Access Compliance Report

Public Rights-of-Way

Intersection ID: 28961	Main Street: MCKEE_RD	Cross Street: TROTWOOD_DR	Location: W
ADA ID: 37861538F77C	Ramp Type: Perp	Initial Pass/Fail: Fail	Overall Compliance: No
Severity Score: 12.5			
Codes/Mitigation Info/Possible Solution		Field Measurements/Component Compliance

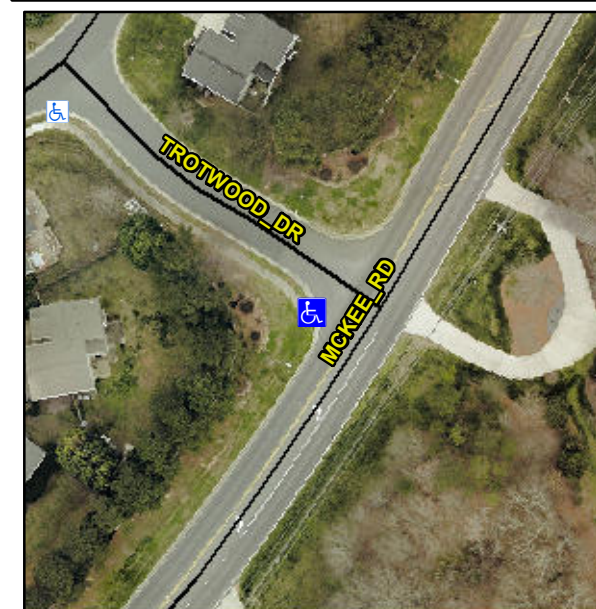
Not Found, R304.2.2

Compliance	Description	Data	Compliance	Description	Data
N/A	Ramp Length (in)	42.0	No	Ramp Slope (%)	10.0
Yes	Ramp Width (in)	56.0	Yes	Ramp XSlope (%)	1.5
N/A	Flare Type LT	N/A	N/A	Flare Type RT	N/A
N/A	Flare Slope LT (%)	N/A	N/A	Flare Slope RT (%)	N/A
N/A	Flare Traversable LT?	N/A	N/A	Flare Traversable RT?	N/A
N/A	Landing Length (in)	N/A	N/A	DWS Provided?	N/A
N/A	Landing Width (in)	N/A	N/A	DWS Contrast?	N/A
N/A	Landing Slope (%)	N/A	N/A	DWS Length (in)	N/A
N/A	Landing X Slope (%)	N/A	N/A	DWS Full Width?	N/A
N/A	Landing Curb? (Y/N)	N/A	N/A	DWS Offset (in)	N/A
N/A	Shared Landing?	N/A			
N/A	Gutter Ponding?	N/A	N/A	Gutter Slope (%)	N/A
N/A	Gutter Lip Ht (in)	N/A	N/A	Gutter X Slope (%)	N/A
N/A	Painted X Walk1?	No	N/A	Painted X Walk2?	N/A
	X Walk 1 Direction	To S		X Walk 2 Direction	N/A
N/A	X Walk 1 Width (in)	N/A	N/A	X Walk 2 Width (in)	N/A
	X Walk 1 Slope (%)	3.5		X Walk 2 Slope (%)	N/A
	X Walk 1 X Slope (%)	2.3		X Walk 2 X Slope (%)	N/A

Remove & Replace Entire Ramp.
